SUBJECT: ISSUANCE OF AMENDMENT NO. 11 TO FACILITY OPERATING LICENSE NO.  
NPF-4 - NORTH ANNA POWER STATION, UNIT NO. 1

License No. NPF-4  
Amendment No. 11

ATTACHMENT TO LICENSE AMENDMENT NO. 11

Figure 6.2-1 Offsite Organization for Facility Management and Technical Support

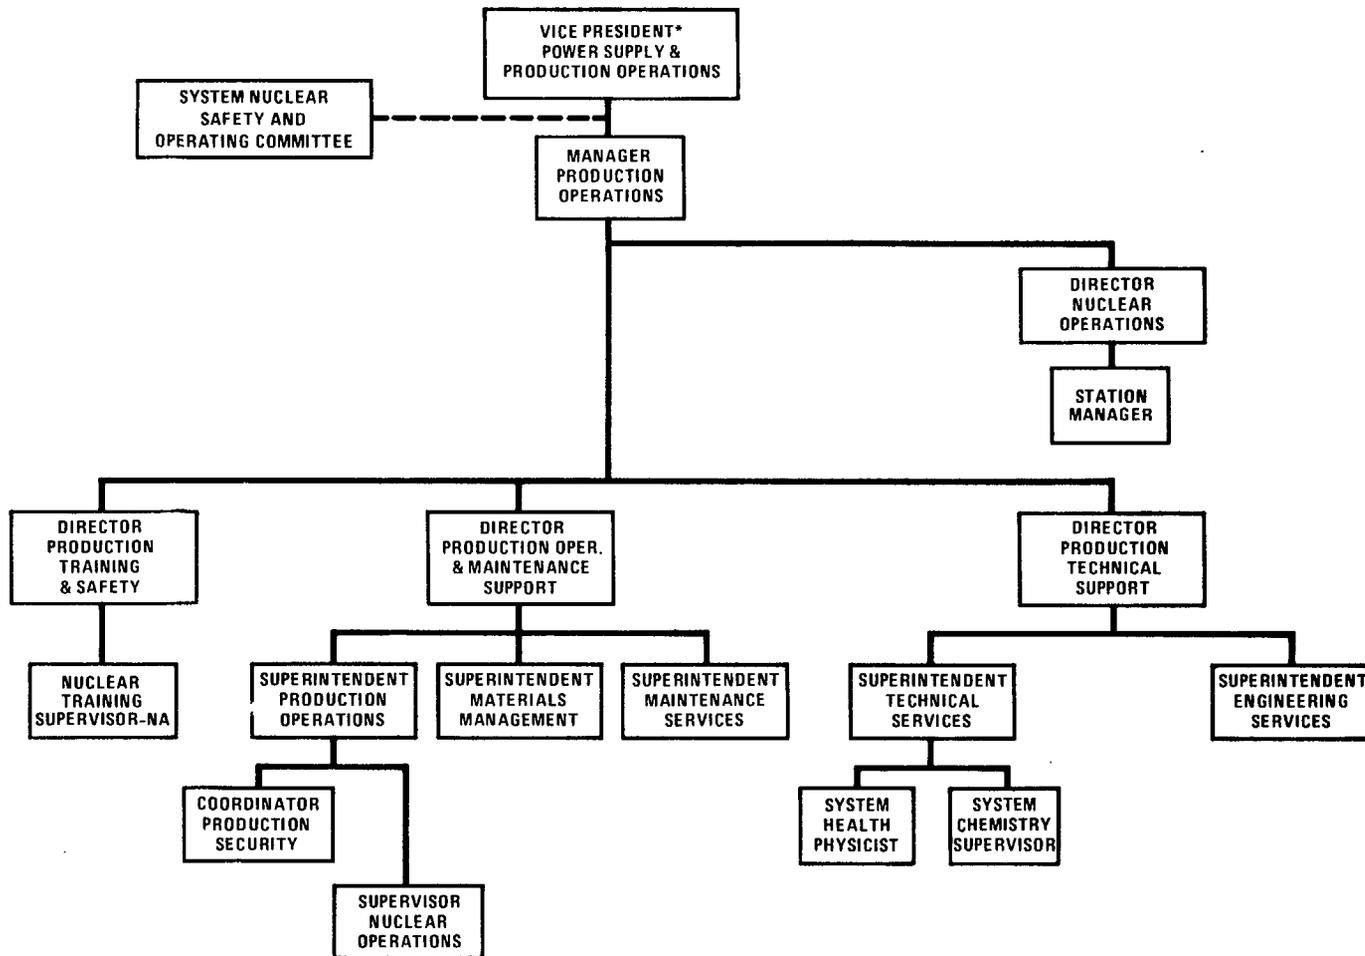
Amendment No. 11 incorporates a new condition in NPF-4 concerning surveillance  
requirements of the emergency diesel generator batteries. The amendment also  
revises Appendices A and B to the Technical Specifications reflecting a re-  
organization of the Production Operation and Maintenance Department both  
onsite and offsite as requested by you. The revised Technical Specification  
page changes are attached to the license amendment.

6.2.1 The offsite organization for facility management and technical support shall be as shown on Figure 6.2-1.

Figure 6.2-2 Facility Organization - North Anna - Units 1 and 2

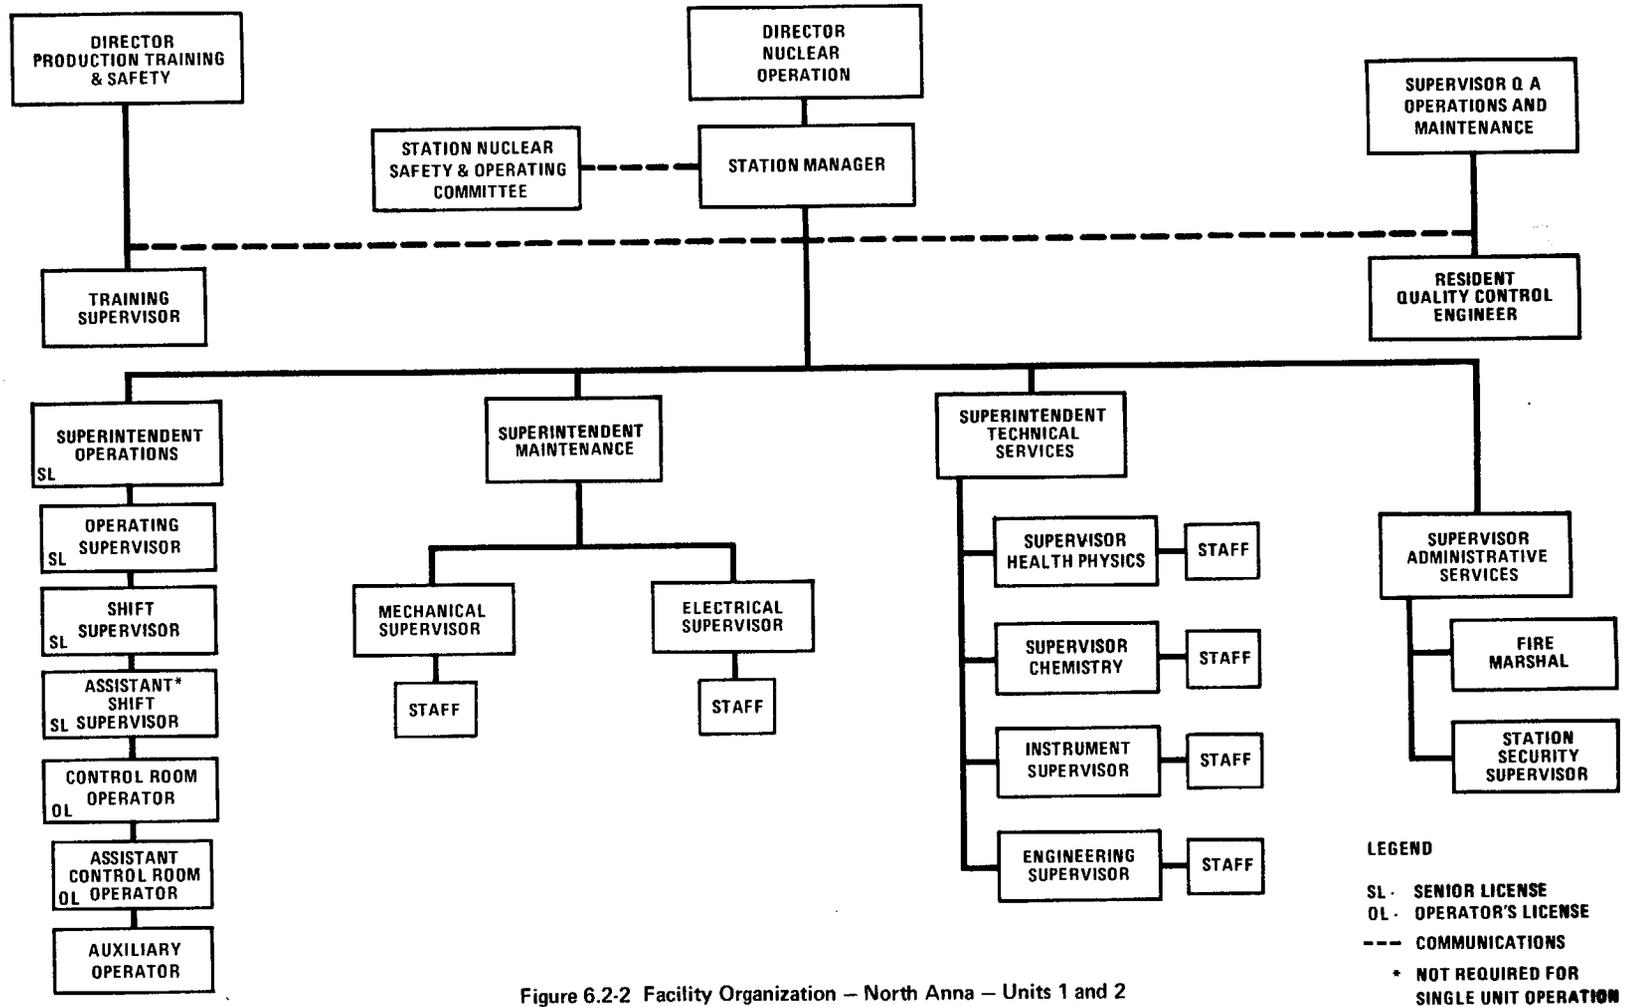
6.2.2 The Facility organization shall be as shown on Figure 6.2-2 and:

The revised organization for the North Anna plant staff is structured to accomplish its function by four groups: the operations group under the supervision of the Superintendent, Operations; the maintenance group under the supervision of the Superintendent, Maintenance; the technical services group under the supervision of the Superintendent, Technical Services; and an administrative group under the supervision of the Supervisor, Administrative Services.

On the basis of our review, we conclude that the plant staff organization meets the provision of American Nuclear Society Standard N18.7-1976/ANS-3.2 as endorsed by Regulatory Guide 1.33, "Quality Assurance Program Requirements (Operation)", and is therefore acceptable to us for the operation of the North Anna Power Station.

ORGANIZATION CHART  
ENVIRONMENTAL TECH SPEC IMPLEMENTATION

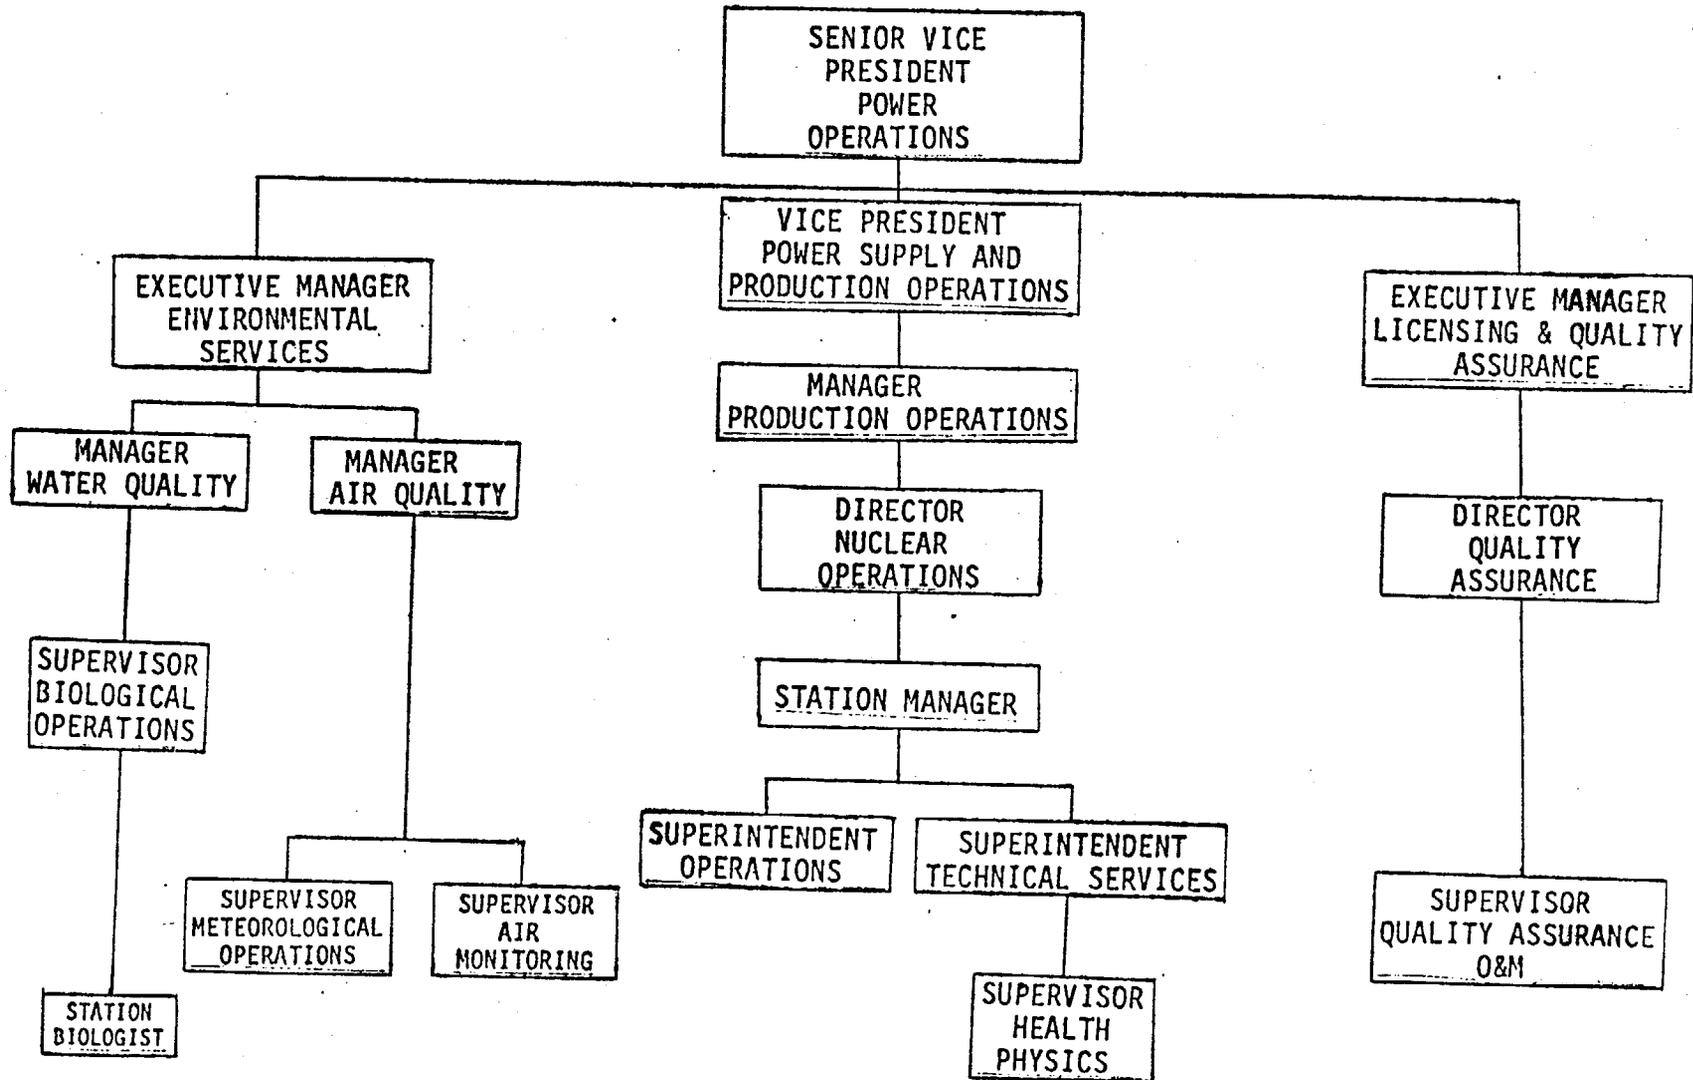
The relationship between the Production Operations Department and the Environmental Services Department is shown in Figure 5.2-1.
